MINUTES OF PREBID MEETING

NIT No.	<ol style="list-style-type: none"> 1. AEGCL/MD/Tech-1145/Aug Trafo/50MVA/T-1/2026/NIT Dated 20.01.2026 2. AEGCL/MD/Tech-1145/Aug Trafo/50MVA/T-2/2026/NIT Dated 20.01.2026 3. AEGCL/MD/Tech-1145/Aug Trafo/50MVA/T-3/2026/NIT Dated 20.01.2026
Name of the Work	<ol style="list-style-type: none"> 1. Supply of 132/33kV, 50MVA Power Transformers and Related Services for APM, Bilasipara, Hatsingimari & Barpeta Substations of AEGCL (Package-T-1) 2. Supply of 132/33kV, 50MVA Power Transformers and Related Services for Nalkata, Dhemaji, Rupai, Margherita & Tinsukia Substations of AEGCL (Package-T-2) 3. Supply of 132/33kV, 50MVA Power Transformers and Related Services for Durlavcherra, Karimganj & Srikona Substations of AEGCL (Package-T-3)
Funding Agency	Internal Source of AEGCL (Term Loan)
Venue & Date of Pre-Bid Meeting	Conference Room O/o the MD, AEGCL, 1 st Floor, Bijulee Bhawan, Paltan Bazar, Guwahati-01 dated 02.02.2026

Table-1:**QUERIES ON BID DOCUMENT (INSTRUCTIONS TO BIDDERS, BDS, TECHINAL ETC.)**

Bid Identification Nos. - AEGCL/MD/Tech-1145/Aug Trafo/50MVA/T-1/2026/BID, Dated 20.01.2026 (Package T-1)
 AEGCL/MD/Tech-1145/Aug Trafo/50MVA/T-2/2026/BID,

Annexure-2

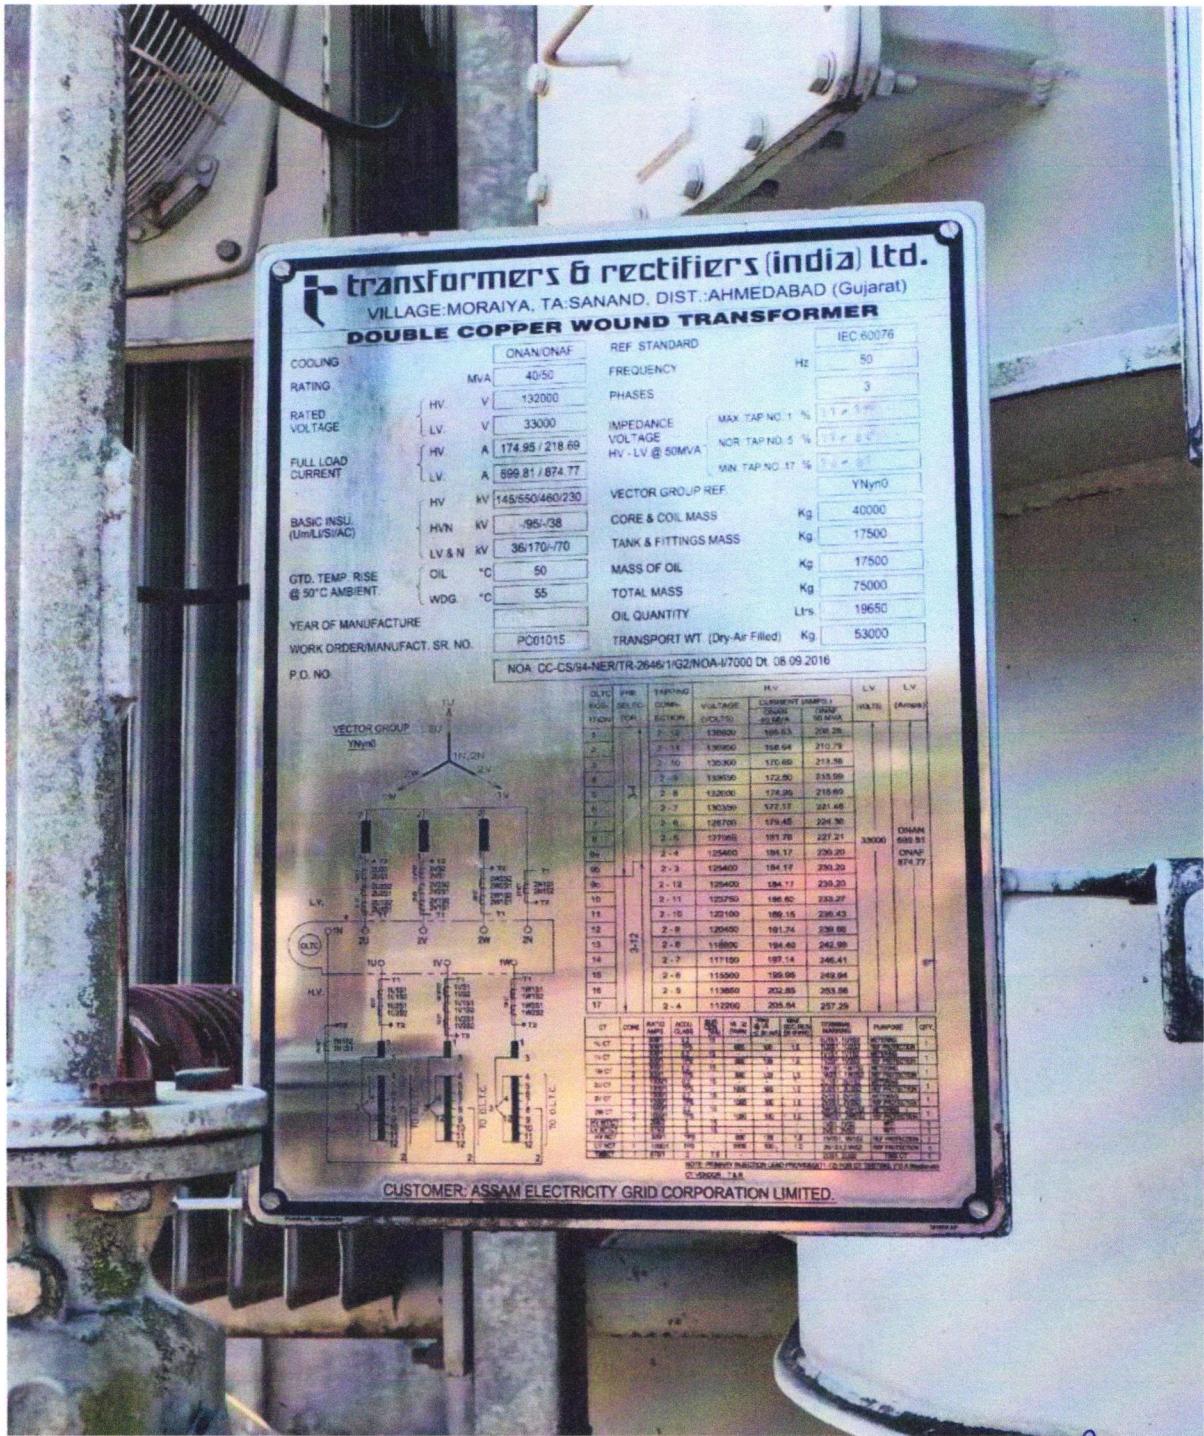
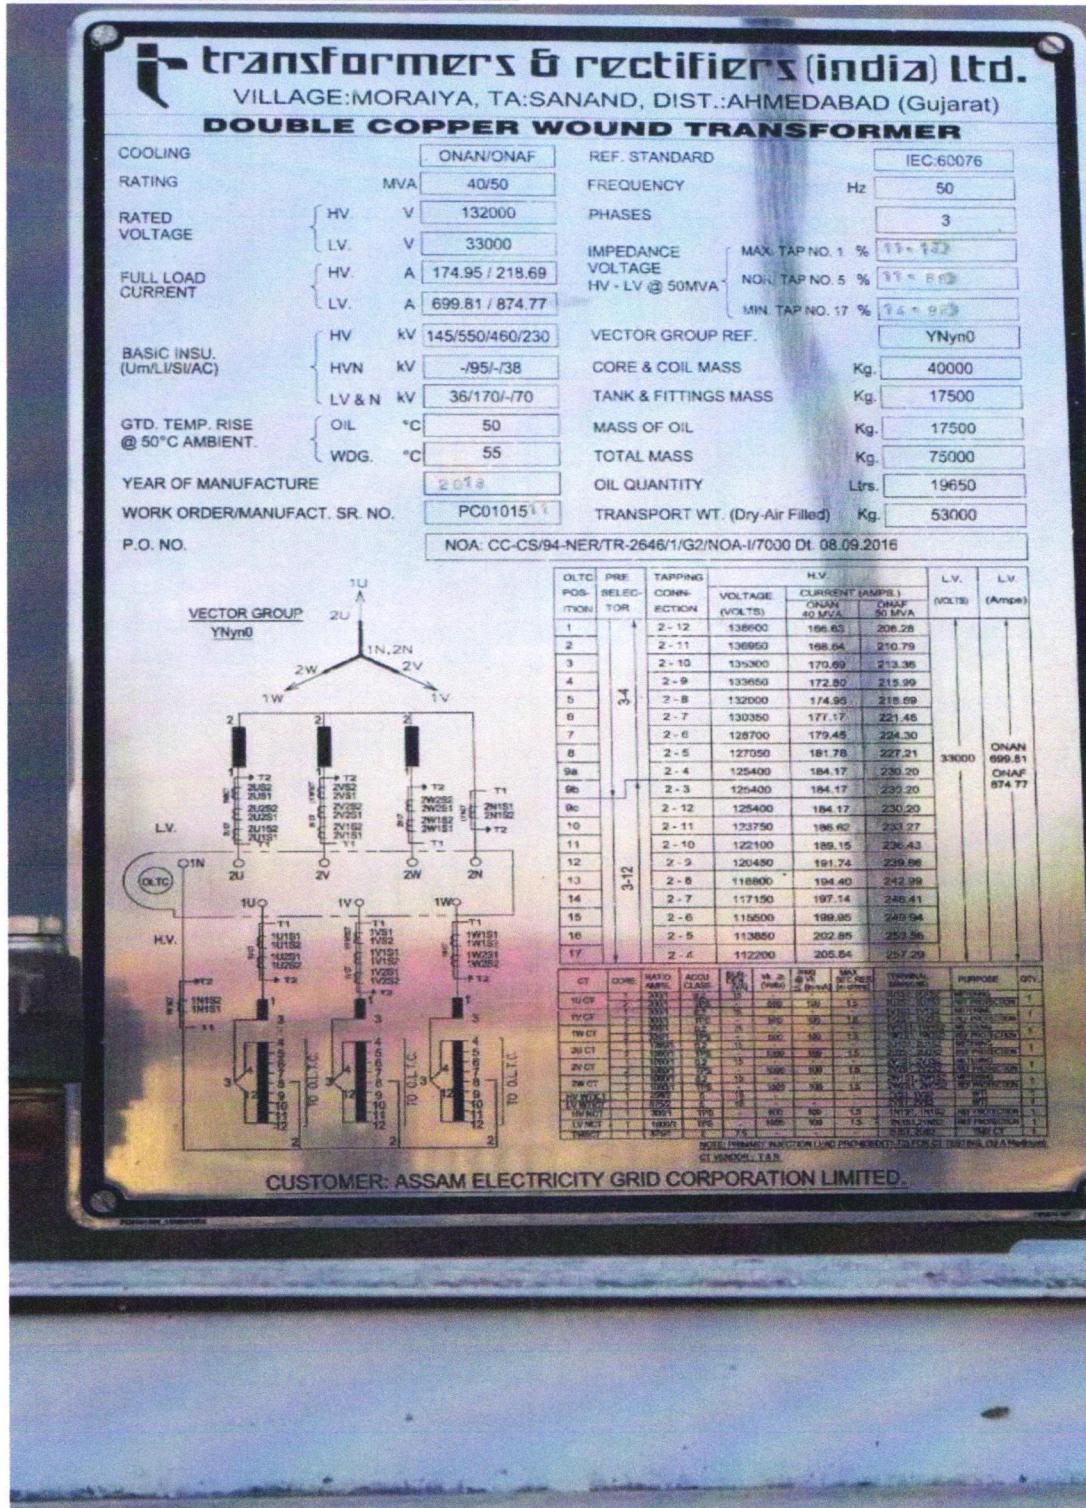
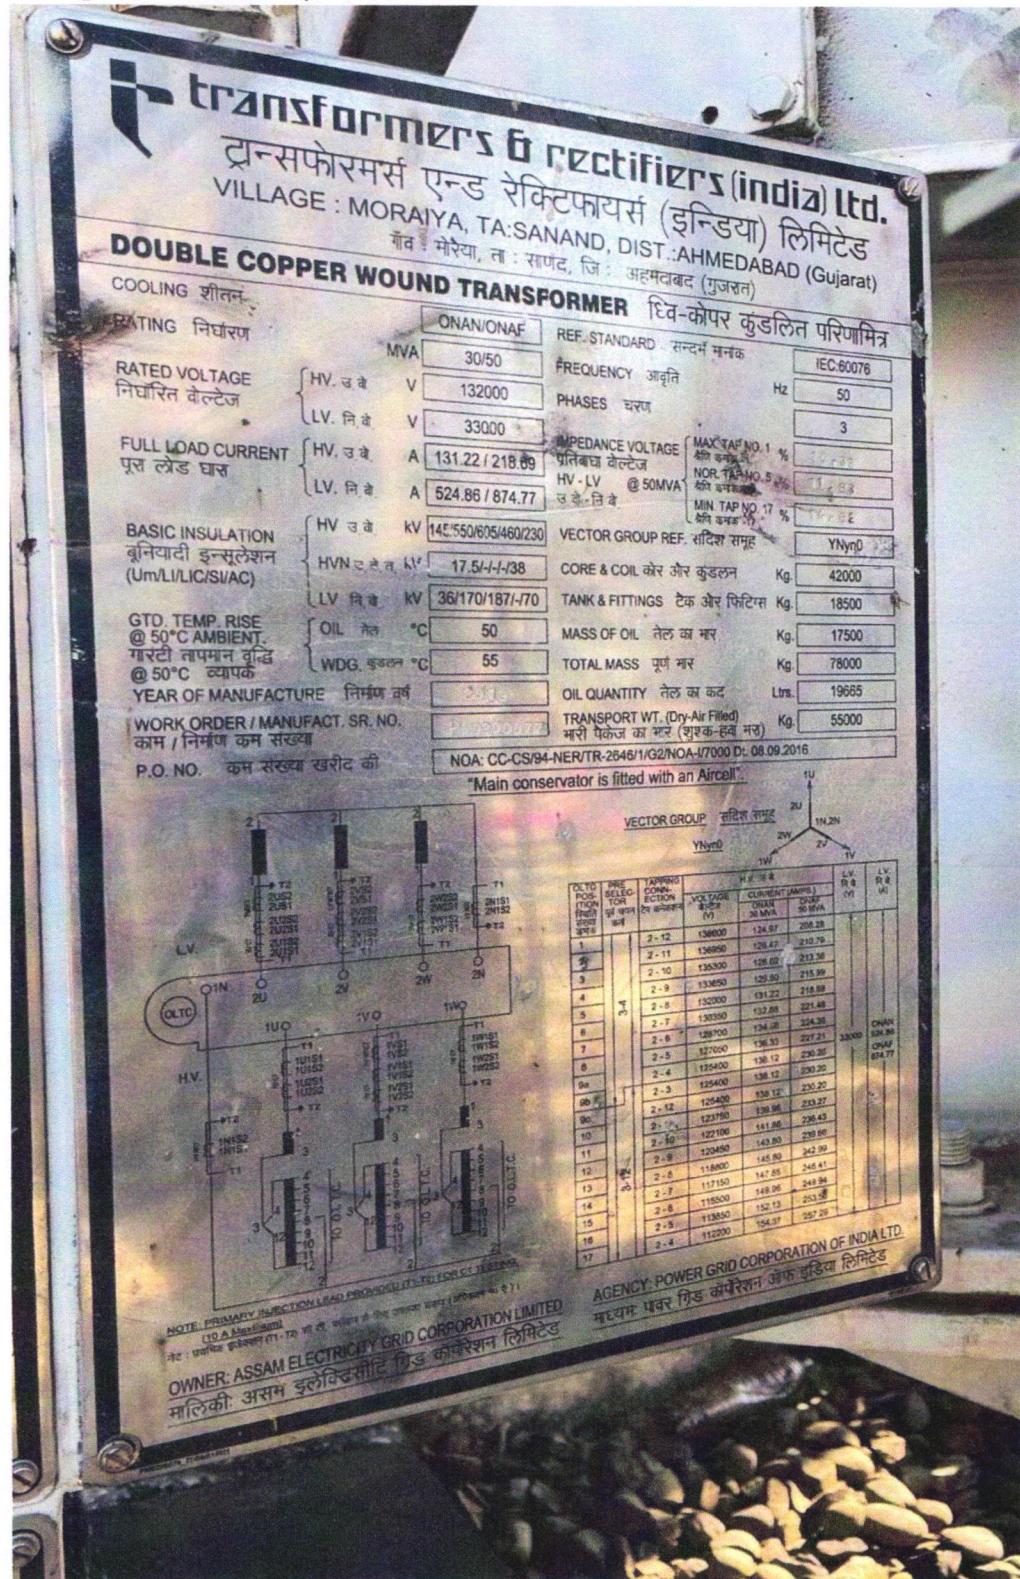
3	"Bid Volume II" Cl. 1.3.1.3 page – 4 of 134	Since details of existing transformer is not provided, we have not considered parallel operation with existing transformer in our offer. If Parallel operation with existing transformer is required. Kindly provide Rating & Diagram Plate and Schematic drawings of RTCC & OLTC of existing transformer.	Parallel operation with existing transformer is required. Name plate of existing transformers is shared in Annexure-2 attached along with this document
4	"Bid Volume II" Cl. 1.29.0 & 1.42.0 page 43,50,51 of 134	Since NIFPES is considered in our offer, "Automatic Mulsifire System (or High Velocity Water Spray System)" is not in BBL scope.	NIFPES is in the scope of the bidder. HVWS not required.
5	"Bid Volume II" Cl. 1.41.0, Annexure K, Annexure O, Annexure P & BOQ1 Sr.no. 1.02 page 49,86,87, 99,100,101,102 of 134	As per the specifications, "Online Dissolved Gas (Multi-gas)", "Online Dissolved Hydrogen and Moisture Measuring Equipment", and "Portable DGA" are mentioned. However, the BOQ includes only "Online Dissolved Gas (Multi-gas)". Accordingly, we have considered only "Online Dissolved Gas (Multi-gas)" in our offer.	As per BOQ
